Subject: Human Health Risk Assessment,
Marina Cove Subdivision, 1801 Hibbard Street, Alameda, California,
and Park Parcel, 1521 Buena Vista Avenue, Alameda, California

Subject: Work Plan
Soil Gas Sampling
Marina Cove Subdivision
Alameda, California

RE: Site No. CO0000869, Marina Cove Development at 1801 Hibbard Street, Alameda, CA

Figure **1A**
 Project 2262

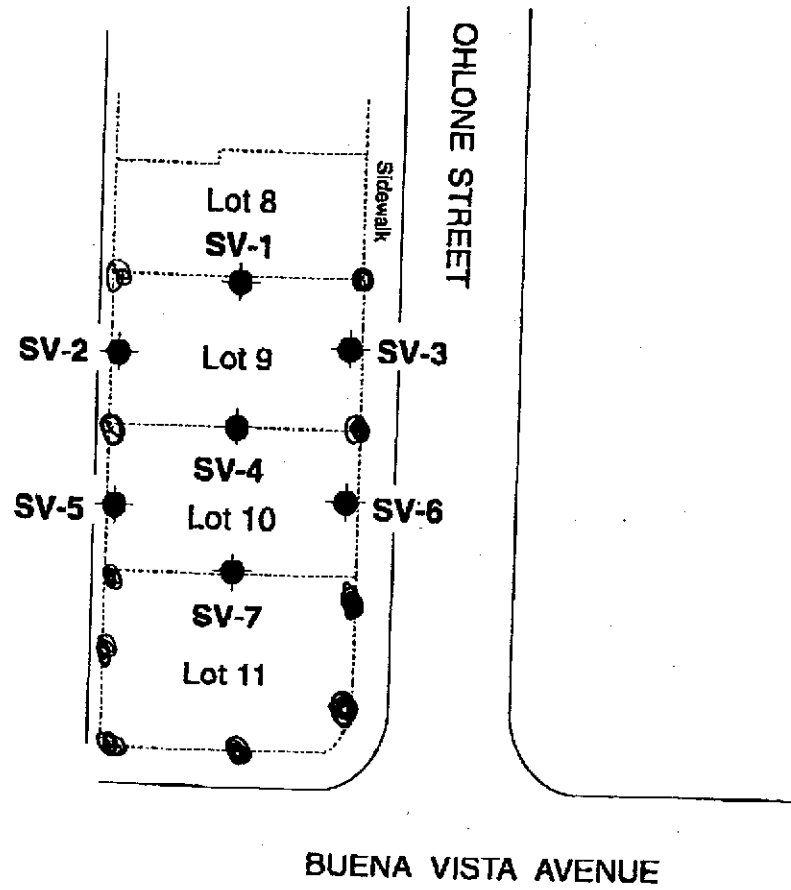
Notes: Soil vapor samples should be collected at a
frequency of one/30 linear feet. Most important
are vapor samples around lots 9 and 10.
The add'l bonny garden lot 11 can be collected
last, in case you run out of time. Soil sample
should also be collected for physical properties -
TOC, bulk density, porosity - do sieve analysis, etc.

every 30 linear feet

*detection limit < 500 µg/m³ for VOCs
in house +
mobile labz*

Figure **1A**

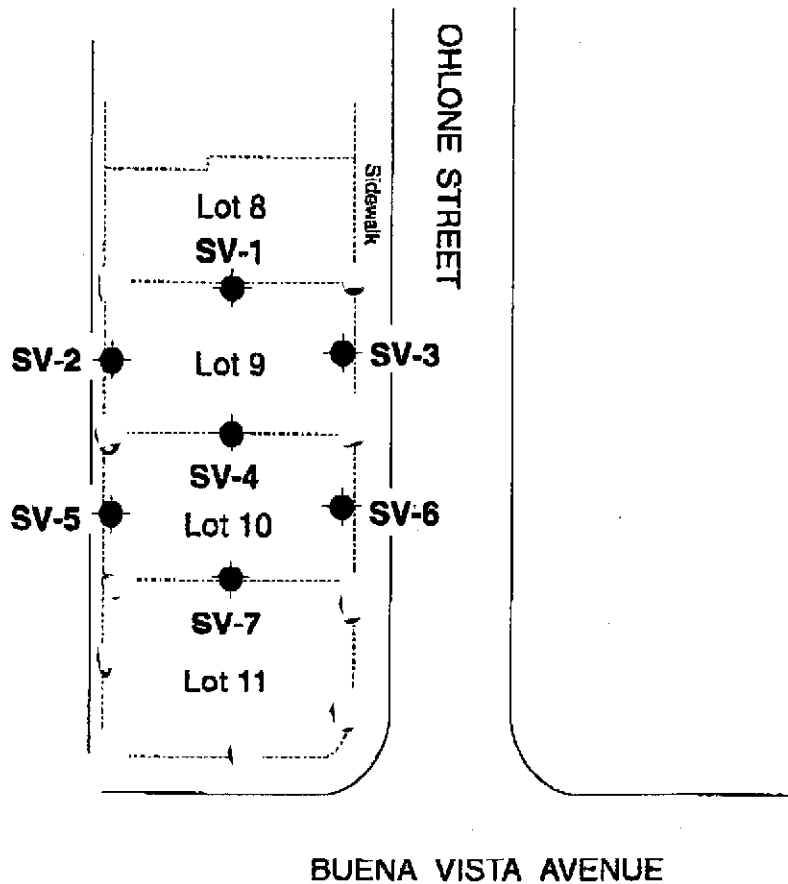
every 30 linear feet

*detection limit $500 \mu\text{g}/\text{m}^3$ for VOC
in house +
mobile lab.*
